**Amendment-4 (dated: 12.06.2024) to RFP Documents for “Network Expansion scheme in Gujarat for drawl of about 3.6 GW load under Phase-I in Jamnagar area” through tariff based competitive bidding process.**

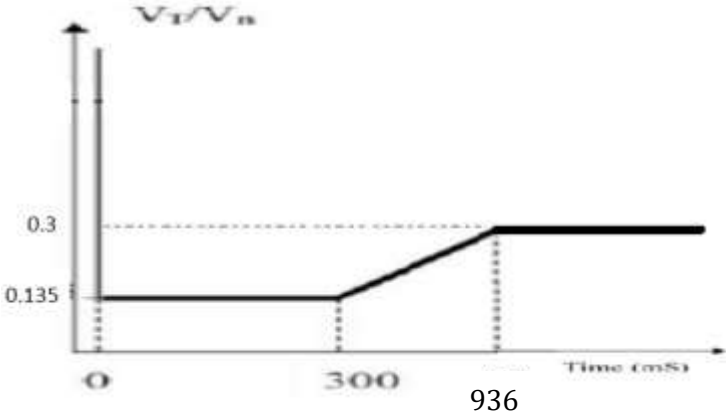
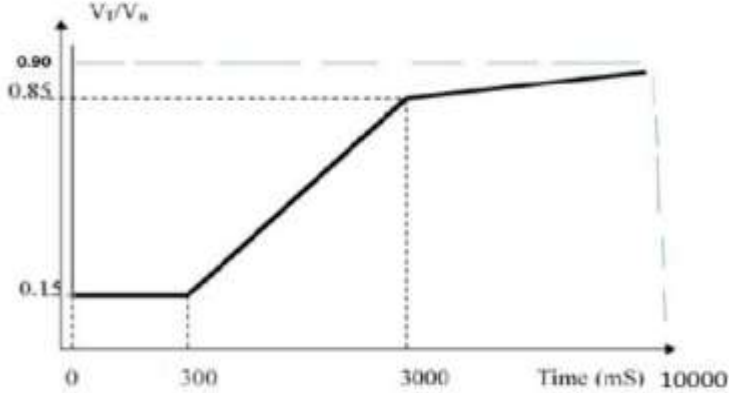
7.	<b>Power System Characteristic of</b>	<i>The STATCOMs shall remain connected to the grid and shall be able to operate at rated reactive power capability when voltage</i>	<b>For STATCOMs near RE complex:</b>

Sl. No.	Clause No.	Existing Clause	New/Revised Clause
	<b>STATCOM</b>	<p>at the interconnection point, on any or all phases dips up to the level depicted by the thick lines in the following curve (for specified time):</p> <p>VT : Actual Voltage; Vn: Nominal Voltage</p> 	<p>The STATCOMs shall remain connected to the grid and shall be able to operate at rated reactive power capability when voltage at the interconnection point, on any single phase or all three phases dips up to the level depicted by the thick lines in the following curve (for specified time) and up to at least 0.3 p.u. in case of two phase faults:</p> <p>VT : Actual Voltage; Vn: Nominal Voltage</p>

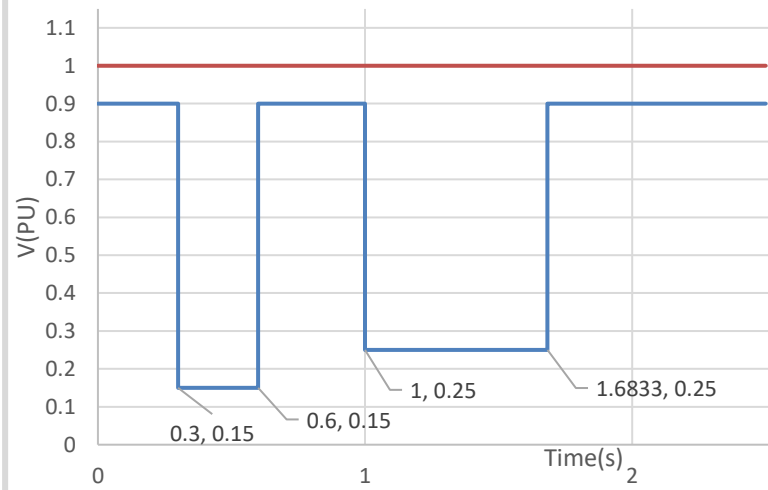
8.	<b>C.6.1</b>  <b>STATCOM</b> <b>Station Ratings</b>	<p>.....</p> <p>.....</p> <p>d) The STATCOM Station should continue to inject reactive power during temporary under voltage down to 54kV (0.135pu) (considering margin of 10% below 0.15p.u. which is the LVRT limit specified for RE generating stations) for the duration 0.3sec (Point C) and STATCOM behavior for voltages above 0.135 pu</p>	<p>.....</p> <p>.....</p> <p>d) The STATCOM Stations <b>near RE Complex shall</b> continue to inject reactive power during temporary under voltage down to <b>60 kV (0.15 pu)</b> for the duration 0.3sec (Point C) and STATCOM behavior for voltages above <b>0.15 pu</b> shall be as specified under section C.5 above; the STATCOM system may be tripped (or</p>

Sl. No.	Clause No.	Existing Clause	New/Revised Clause																		
		<p>shall be as specified under section C.5 above, which also specifies operation at under voltage down to 120kV (0.3pu) for the duration 5sec; the STATCOM system may be tripped (or blocked) if the under voltage persists for time beyond limits specified under section C.5 above.</p> <p>.....</p> <p>.....</p>	<p>blocked) if the under voltage persists for time beyond limits specified under section C.5 above.</p> <p><b>The STATCOM Stations (other than RE Complex) shall continue to inject reactive power during temporary under voltage down to 120 kV (0.3 pu) (Point-C) for the duration 5 sec; the STATCOM system may be tripped (or blocked) if the under voltage persists for time beyond limits specified under section C.5 above.</b></p> <p>.....</p> <p>.....</p>
